LIGO-T960023-00-D

FROM:	Deutze Durance
ORGANIZATION:	Caltech / LIGO
FAX NUMBER:	
VOICE NUMBER:	
REFER TO:	
SUBJECT:	Common Mode Servo

TITLE: MARK II LASER LOOP AMPLIFIER

MC PIEZO DRIVEN FILTER/PREAMP

LASER STABILIZATION LOOP BLOCK DIAGRAM

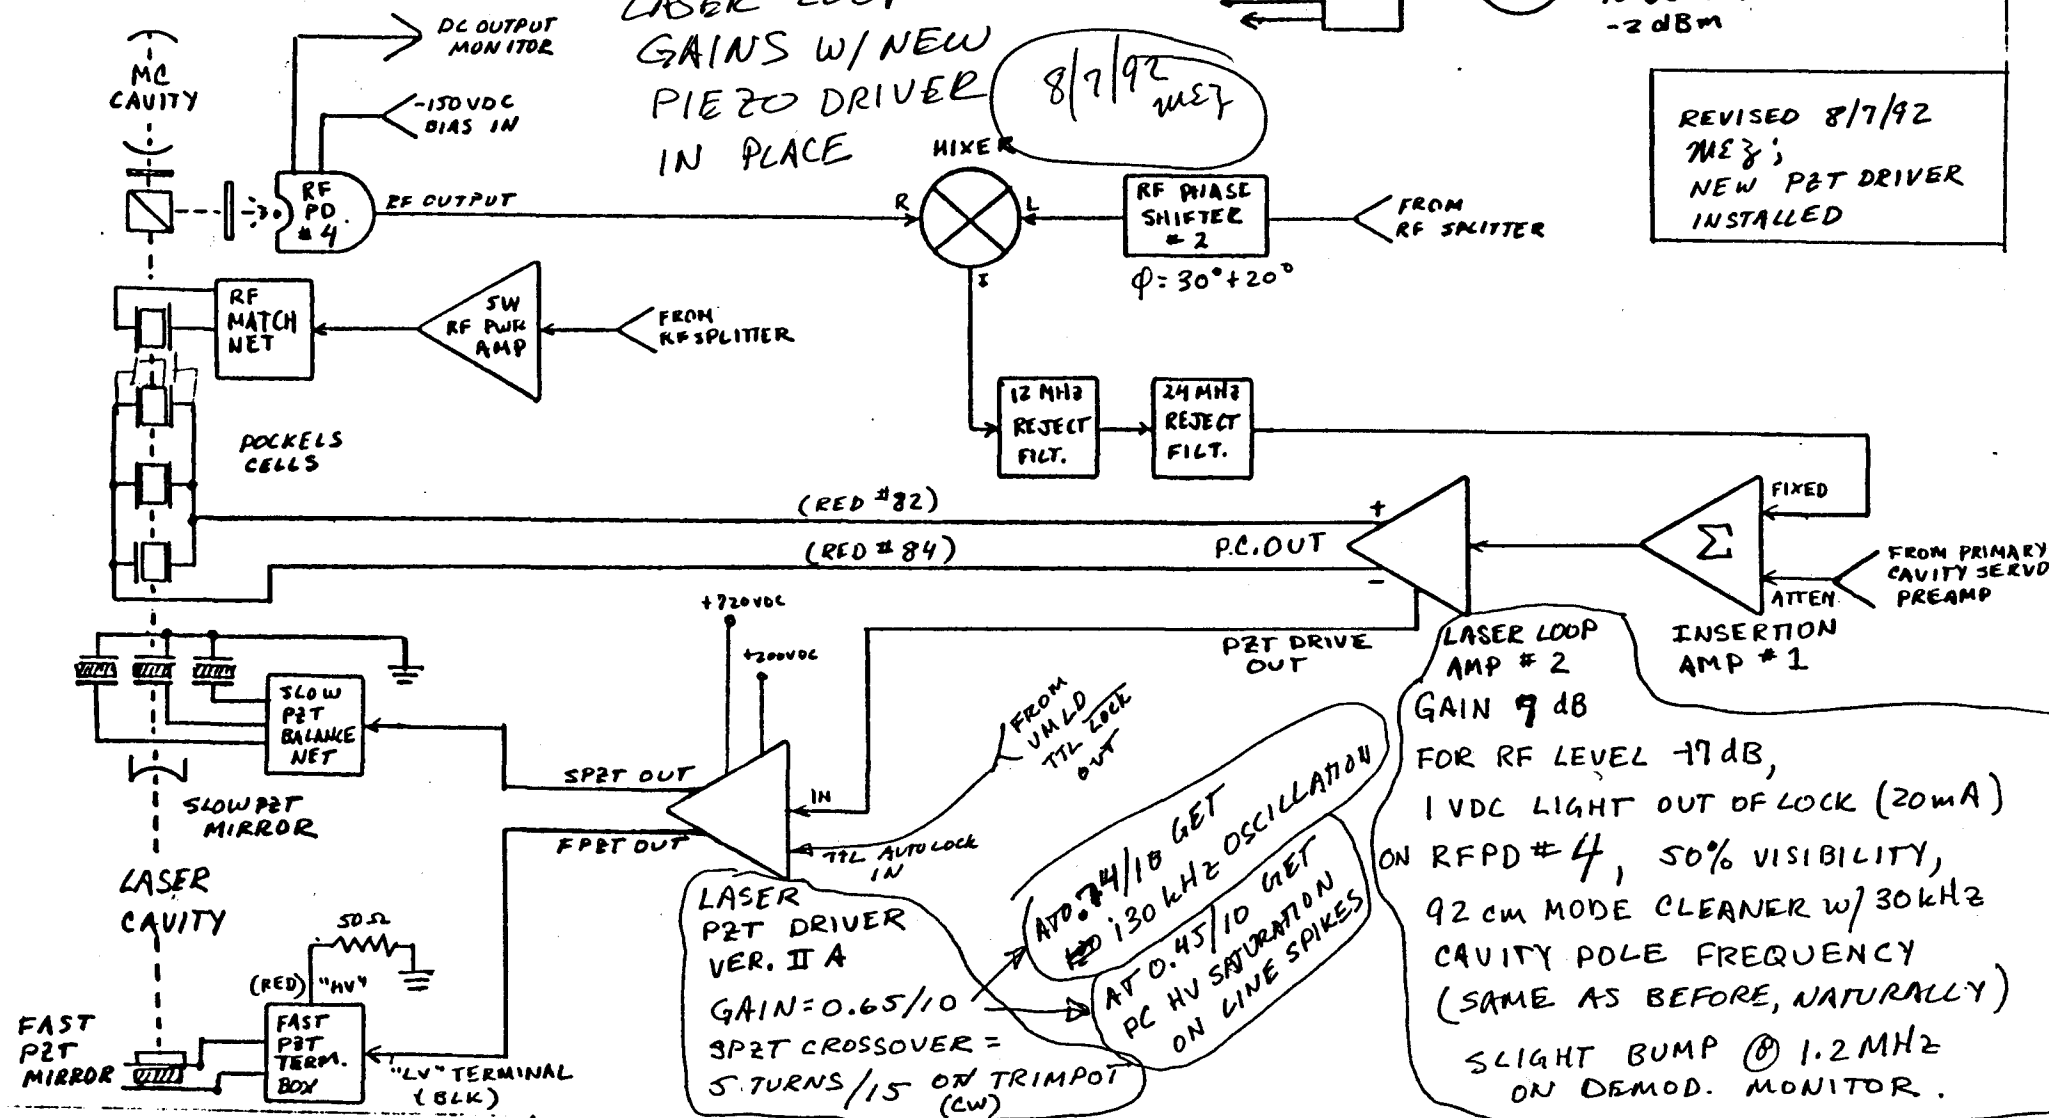
REVISED 8/7/92
MEZ;
NEW PZT DRIVER
INSTALLED

LASER
PZT DRIVER
VER. II A
GAIN=0.65/10
SPRT CROSSOVER =
5 TURNS / 15 ON TRIMPOT (CW)

AT 0.74/10 GET
130 kHz OSCILLATION
AT 0.45/10 GET
PC HV SATURATION
ON LINE SPIKES

LASER LOOP
AMP # 2
GAIN 9 dB
FOR RF LEVEL -7 dB,
1 VDC LIGHT OUT OF LOCK (20mA)
ON RFPD # 4, 50% VISIBILITY,
92 CM MODE CLEANER W/ 30kHz
CAVITY POLE FREQUENCY
(SAME AS BEFORE, NATURALLY)
SLIGHT BUMP @ 1.2 MHz
ON DEMOD. MONITOR.

NOTE: POLARITY (ONLY)
IS REVERSED
WITH RESPECT TO
OLD P.Z.T. DRIVE
SYSTEM (PIEZO SHOULD
REF. K. WITH -200V REVERSE BIAS)

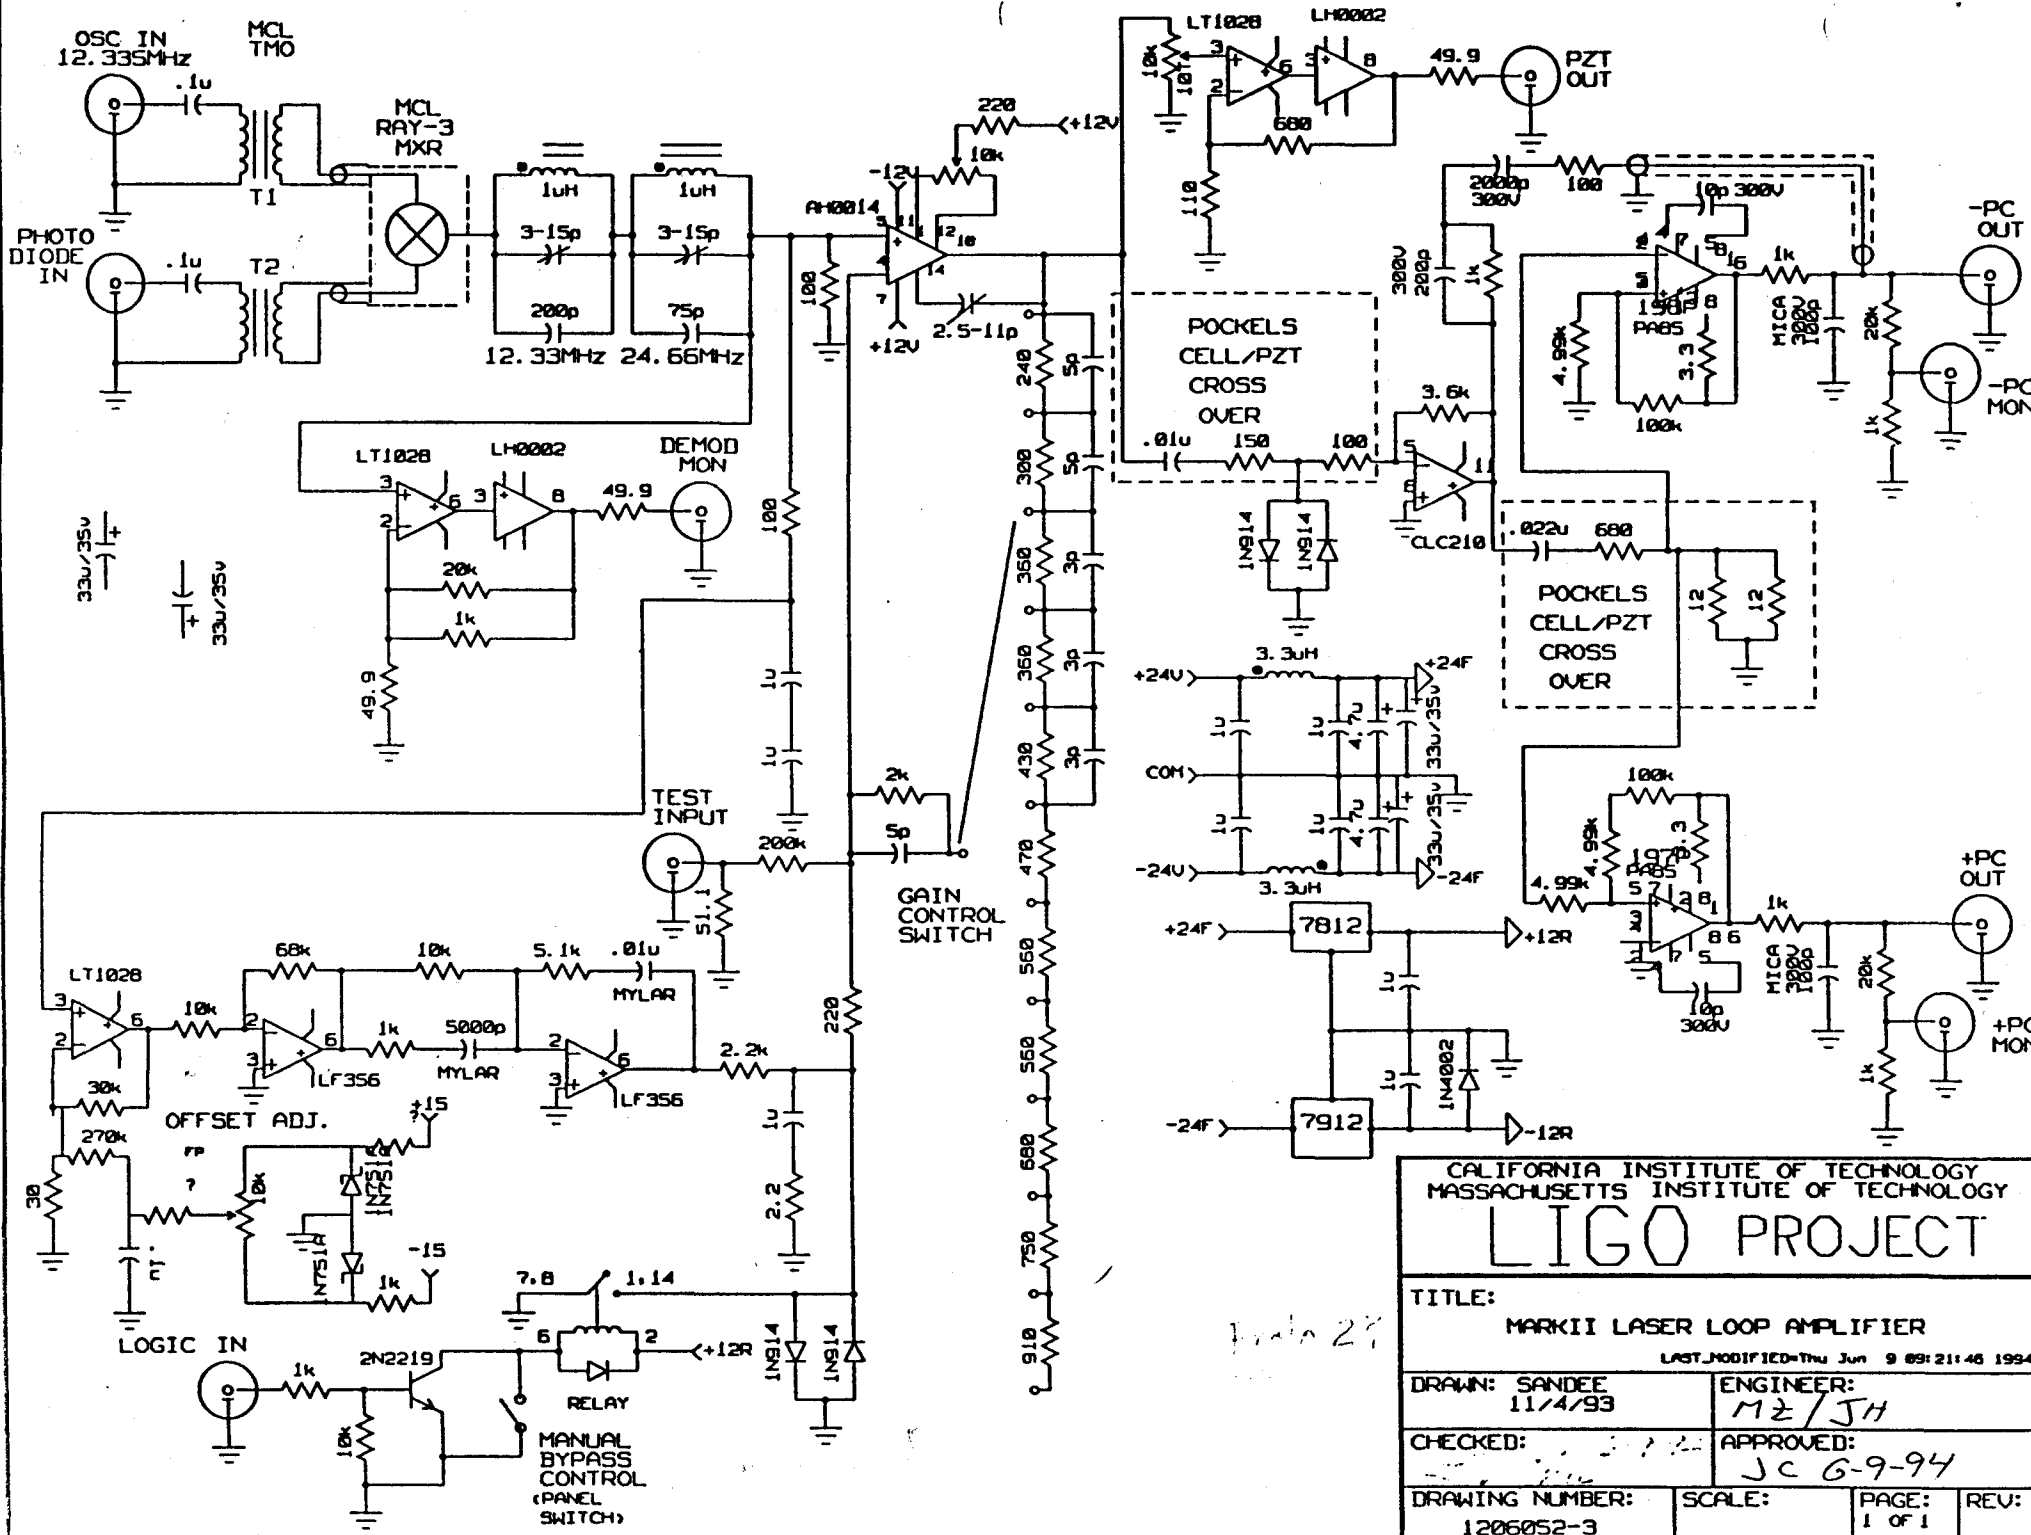
SLOW PZT HAS
SAME POLARITY AS
BEFORE, BUT ⊖ SIDES
ARE NOW JOINED TO GND
INSTEAD OF 0-500V POT WIPER

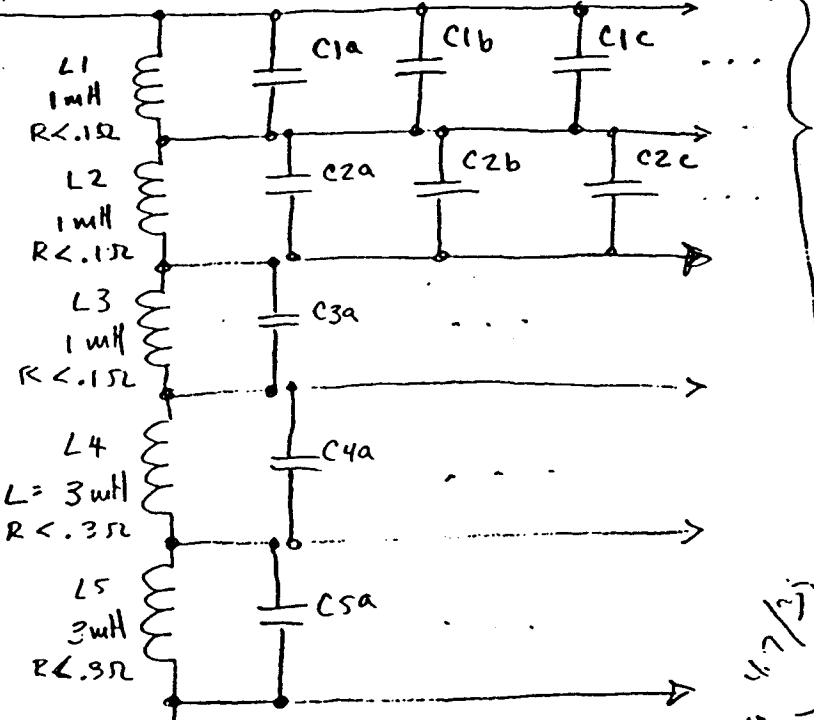
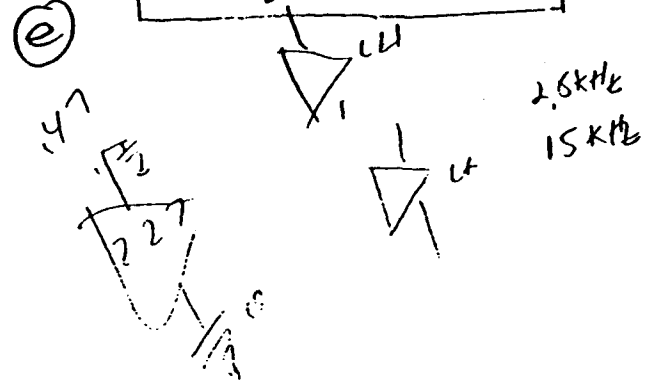
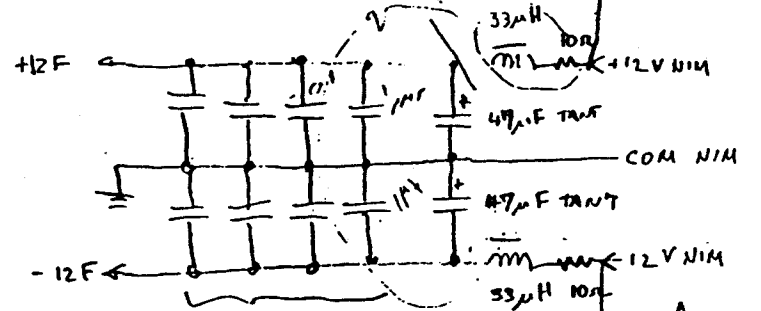
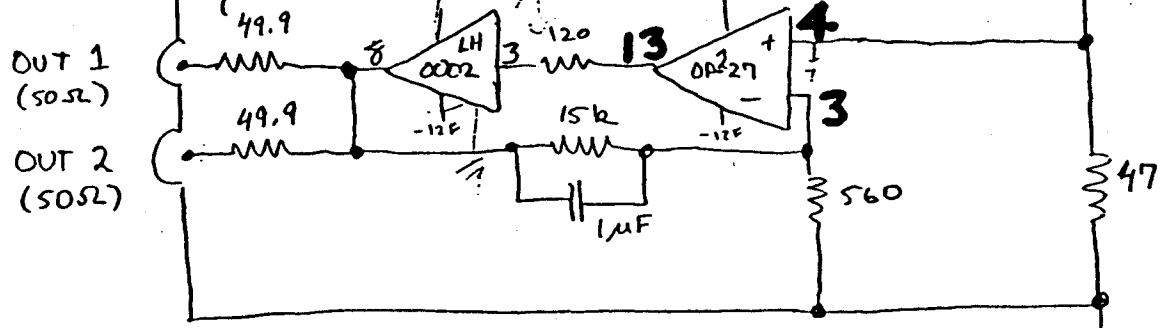
CHANGED FROM 47 TO 10 TO INCREASE NOTCH DEPTH

ALL C'S ACCESSIBLE FOR TUNING; LAYOUT TO ACCOMMODATE 1 BIG MYLAR CAP UP TO 3μF IF POSSIBLE.
